UNITED STATES PATENT AND TRADEMARK OFFICE

APPLICATION NO.	FILING DATE	FIRST NAMED INVENTOR	ATTORNEY DOCKET NO.	CONFIRMATION NO.
10/657,975	09/09/2003	John D. VanderWerf	W0686.10.U	2788

Office Action Summary	Application No.	Applicant(s)	
	10/657,975	VANDERWERF ET AL <i>AL</i>	
	Examiner	Art Unit	
	David T. Fidei	3728

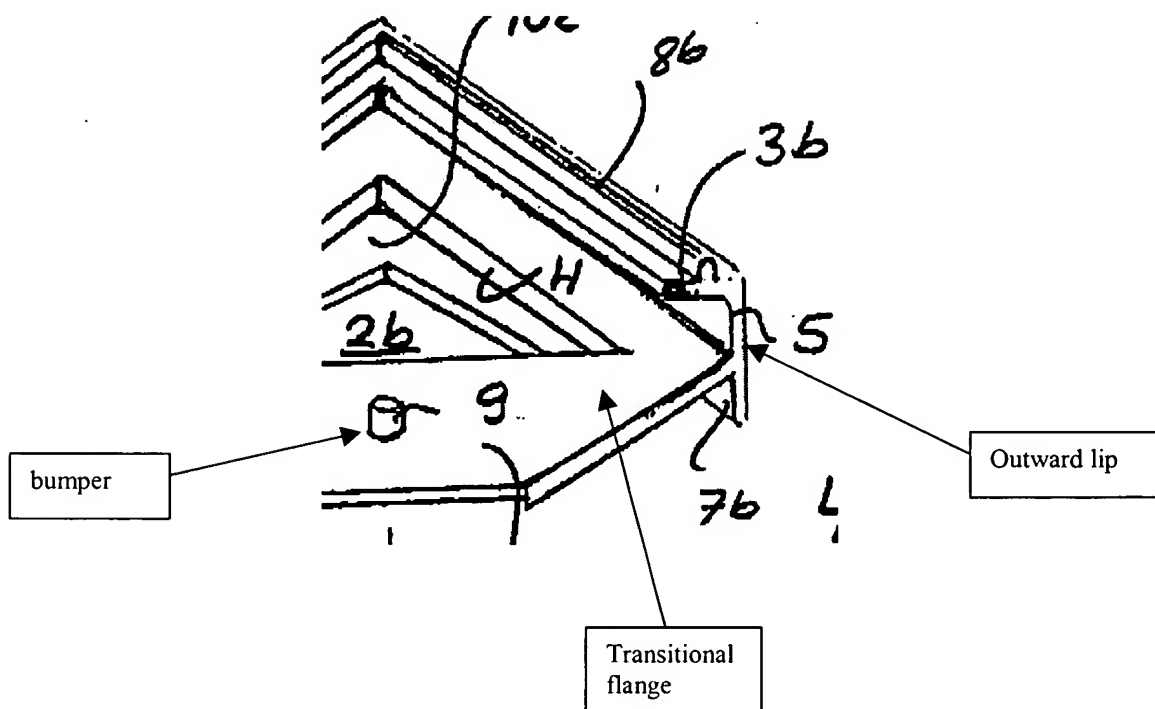
As to claim 6, the lip member corner flange 3b curves inwardly in a hook-like manner as shown in figure 1.

As to claim 7, the frontal barrier member 2 a includes a raised bumper member 9 extending outwardly from the inner base surface to from the outer bumper surface.

As to claim 8, the bumper member includes a substantially flat upper surface.

As to claim 9, the width-to-height ratio of said bumper member 9 appears to be at least 1.0.

As to claim 12, the corner guard includes a substantially flat transition flange that couples said raised bumper 9 member to the proximal end of said lip member 5, see the diagram below.
